PUBLIC COMMENTS FOR IBR JOINT ADVISORY GROUP

Received between July 21, 2025 and August 25, 2025

Joint CAG/EAG Public Comment

Pedestrian/Bike Trail Strategy with IBR

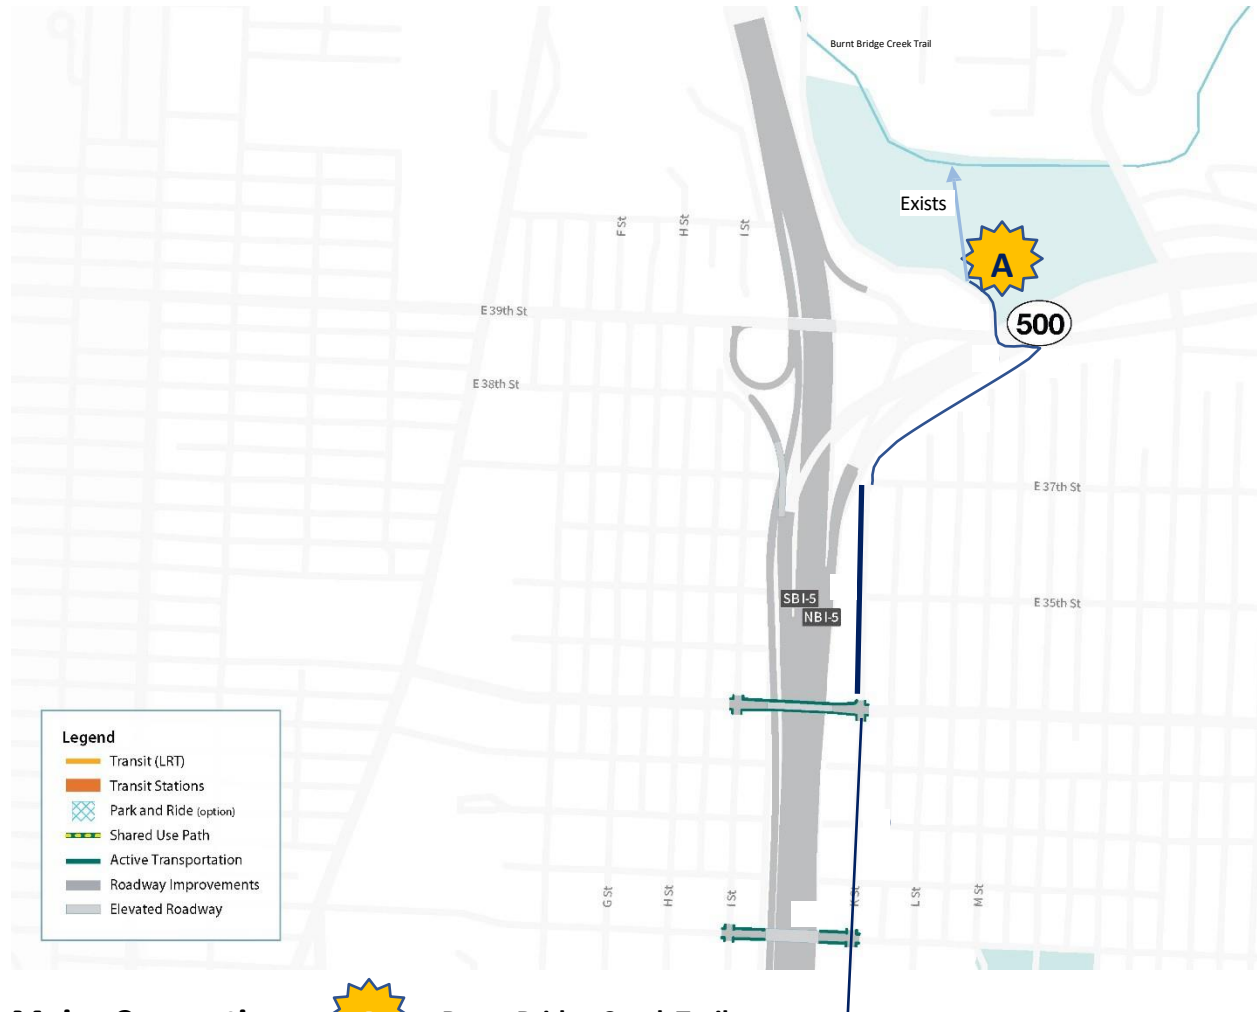
Major Connections **Burnt Bridge Creek Trail**

1. Pave trail 12+foot wide path on the east side of NE Leverich Parkway beside the bollards for 300 feet to the linkage to Burnt Bridge Creek Trail/Leverich Park path.

2. Widen sidewalk into path (14 feet) on the south side of E. 39th Street for 125 feet and cross at existing signal at NE Leverich Park Way
3. Widen the existing trail link from the cul-de-sac at N Street to East 39th Street

4. From N Street cul-de-sac proceed south off-road as a 2'+12'+2' trail (see sketch to right) until K Street/E. 37th Street - consider connections to L Street and M Street

5. At K Street/E. 37th Street, create a one-sided trail on the west side of K Street paving to the fence line from the back of curb ~12 feet continuing south to East 33rd Street and crossover to K Street

6. Use K as a shared route between East 33rd Street to East 29th Street
7. At E. 29th, install bike lane on bridge and widen sidewalks linking east to K Street (plan is blank here)

Pedestrian/Bike Trail Strategy with IBR

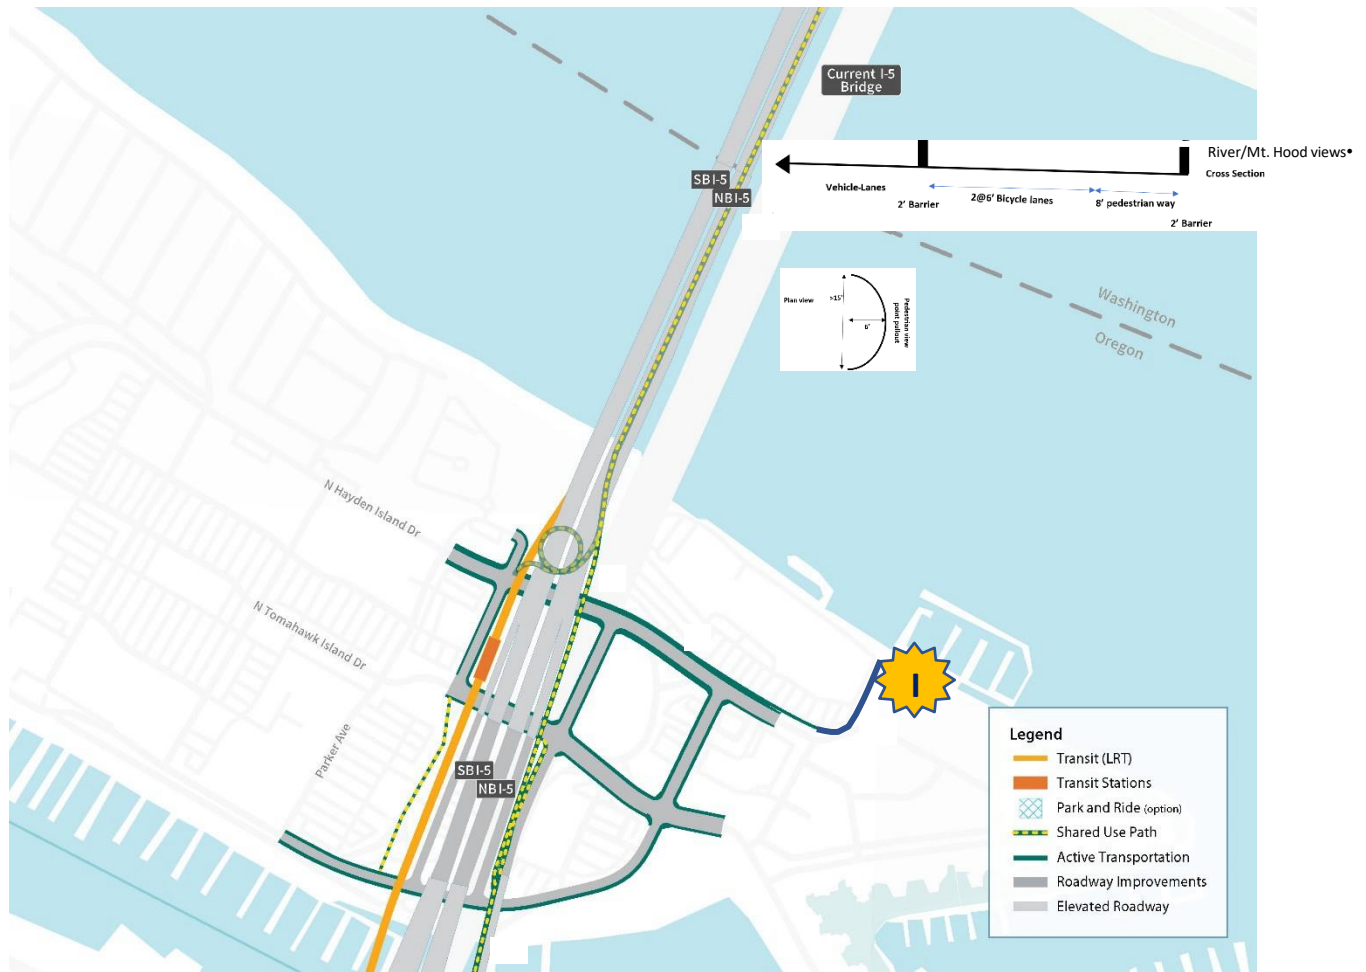
- F** Fort Vancouver
North end Discovery Historic Loop Trail
- G** Land Bridge + Downtown
- H** Columbia Riverfront Renaissance Trail

1. Shared use of Officers Row north of East Evergreen Blvd
2. Either shared use of Anderson Road or use remnant space of what's left of Anderson for a 2-12-2 trail north to the Community Connector.

3. Continue the I-5 trail as 2-12-2 trail northward from E. Fifth Street on backside of Western Lands parking lot north to Anderson.
4. Improve the south side of E. Fifth Street to the east linking to the Discovery Historic Loop Trail connection 1,400 feet east with a clear 12-foot trail up against the existing cyclone fence

5. Cross SR 14 at opportune elevation from Land Bridge as 14-foot trail northward to edge of Ft. Vancouver (SE corner) adjacent to I-5 N/B to downtown Vancouver ramp connecting to E. Fifth St

6. Provide 20' IBR ped/bike facility with view points on east side of structure hugging the N/B I-5 E/B SR 14 off-ramp, at the optimal elevation point hold the trail grade to link to Land Bridge, possibly reusing old S/B I-5 to SR 14 E/B off-ramp

7. Add an elevator + stairway at the crossing of I-5 and SE Columbia Way (no helix) expanding the plaza that exists on the south side of SE Columbia Way linking to the waterfront connection across the riverside of Who Song's and Larry's connecting to Columbia Waterfront Renaissance Trail. Be sure that 12-foot minimum linkages are built on the south side of SE Columbia Way to the existing landscape buffered trail
